**City of Bellevue
Development Services Department
Land Use Division Staff Report**

Proposal Name: East Link South Bellevue Segment

Proposal Description: Design and Mitigation Permit approval to construct the East Link regional light rail transit facilities (RLRT facilities) and regional light rail transit system (RLRT system) in the South Bellevue area of the City of Bellevue.

File Number: 14-134626 LD

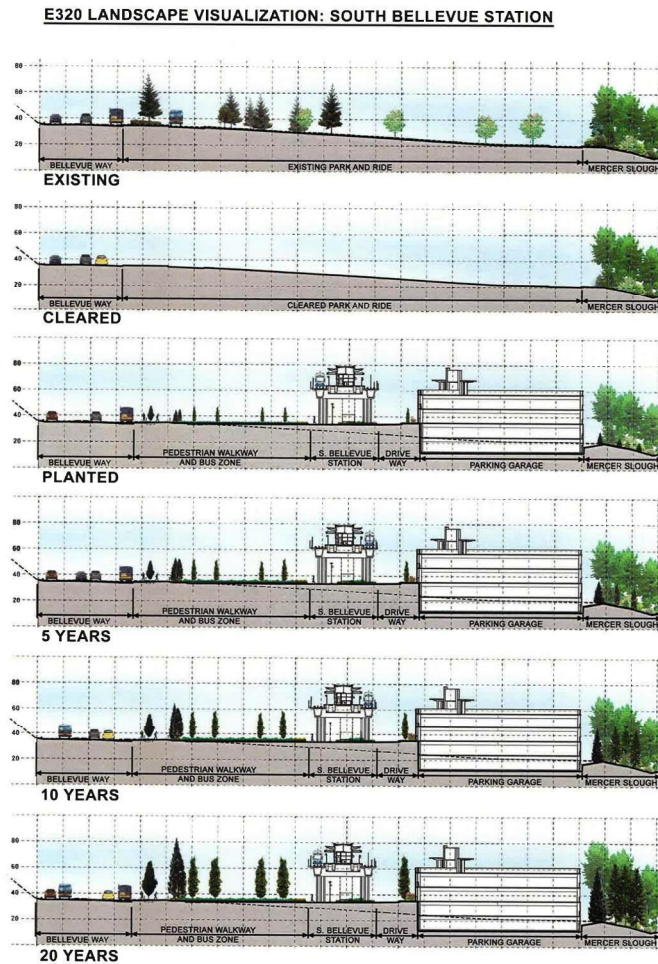
Finding: A combination of planter strips and other landscaping has been proposed by Sound Transit in compliance with these requirements except as noted in the ALO request. Planter strips have been provided along the linear corridor alignment and as mitigation for the ALO request the city has worked with Sound Transit to identify additional enhancement areas to provide an equal or better result based on context. Due to a variety of reasons including City of Bellevue Transportation lighting criteria, constraints within the right of way section, and clear zone requirements for light rail tracks and guideway, a request to modify the requirement for street trees is included as part of the ALO. Refer to ALO discussion below.

Sound Transit has provided a 30 feet of Transition Area Design District landscaping within the RLRT transition area adjacent to the residential development on the west side of 112th Ave SE north of the road over rail crossover. Placement of trees was done in consideration of light rail tree clear zone requirements. Trees to be planted in the buffer include Western Red Cedar (*Thuja Plicata*), Douglas Fir (*Pseudotsuga Menziesii*), Greenspire Littleleaf Linden (*Tilia Cordata* 'Grenspire'), and Red Sunset Maple (*Acer Rubrum* 'Franksred').

E320 LANDSCAPE VISUALIZATION: 112TH AVE SE

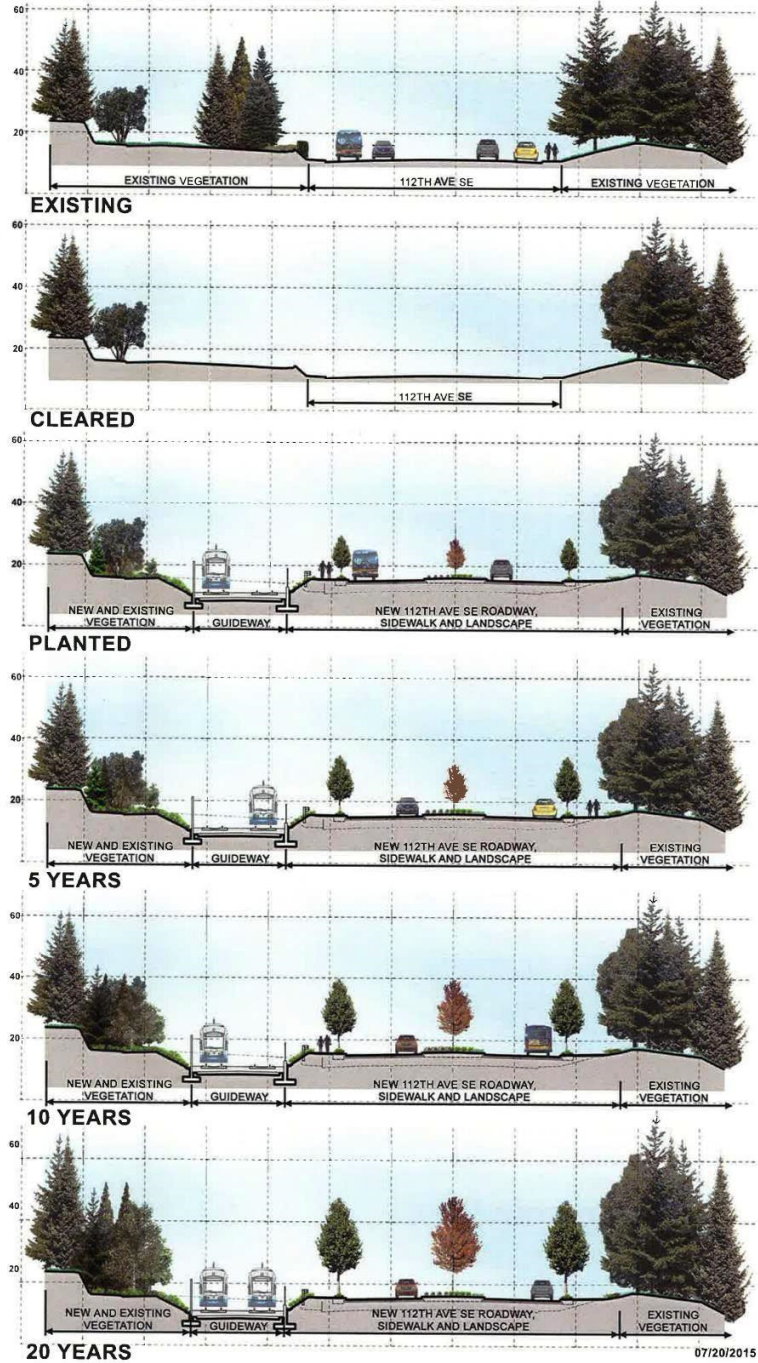
At the request of the city, Sound Transit has provided visual simulations of the growth of proposed landscaping over a period of 20 years.
